# **PUBLIC COMMENT REPORT**

## **PUBLIC COMMENTS RECEIVED ON FIRST PUBLIC REVIEW DRAFT**

## **ICC/ANSI A117.1 STANDARD DEVELOPMENT - 2014 EDITION**

## **ICC A117.1 Standard – Accessible and Usable Buildings and Facilities**

FIG. C

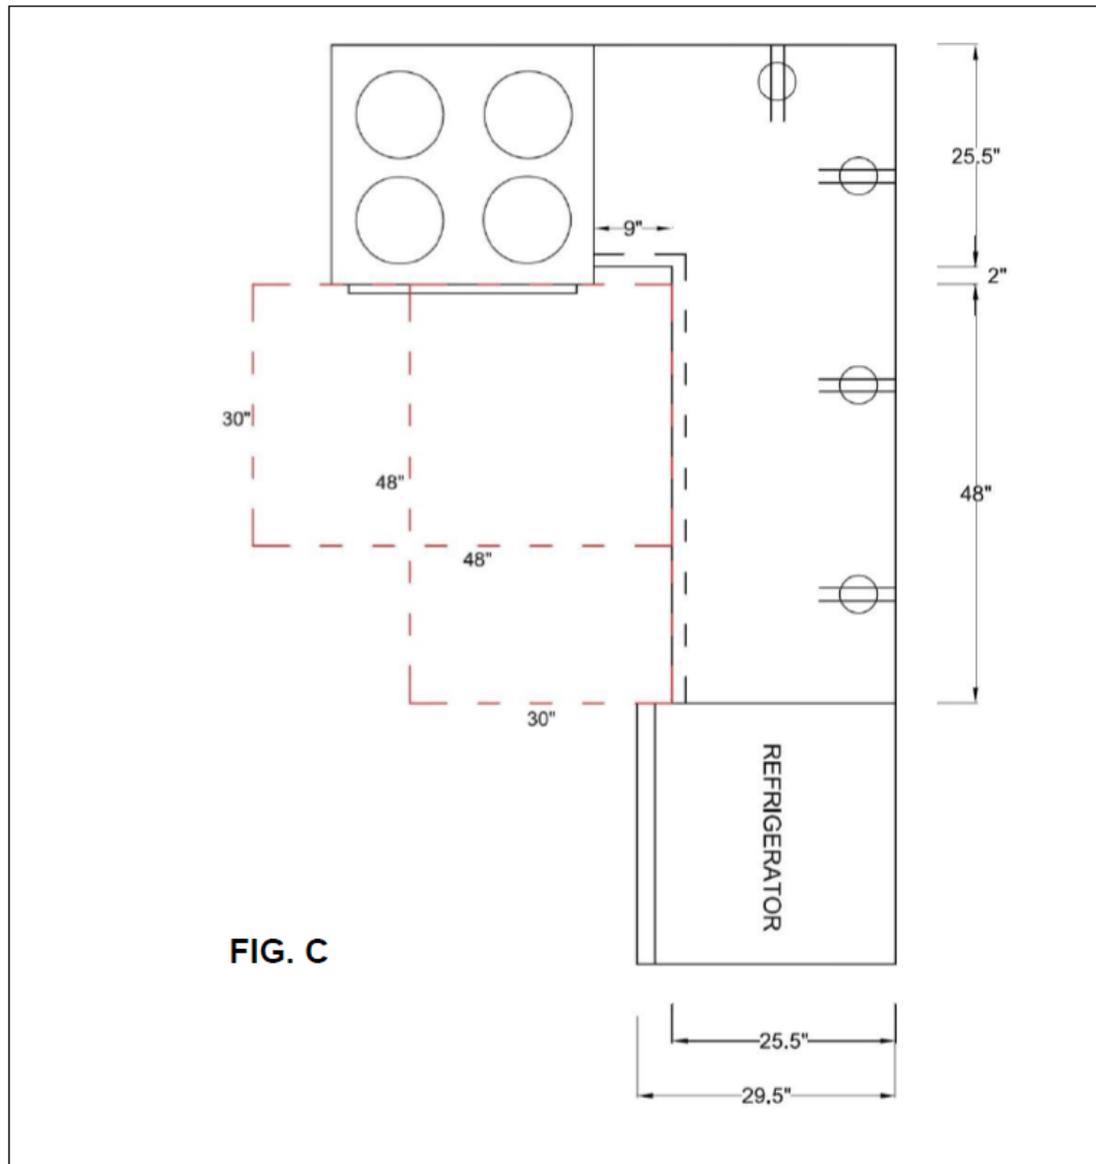
Section 1004.9, Exception 2 certainly is improved in that only one of a number of outlets serving a run of countertop uninterrupted by a sink or appliance is required to be accessible; whereas, before only one was permitted to be inaccessible. However, it does not go far enough. Exception 3 attempts to provide an exception for corner countertops recognizing that the clear floor space cannot be positioned at tight corners flanked by appliances, but again, it doesn't go far enough. Exception 3 contemplates difficulty with achieving compliance only when appliances (range and refrigerator) flank a tight corner. Again, compliance cannot be achieved if there is not enough space on one or both legs of the corner (measured along the front edge of the countertop) to
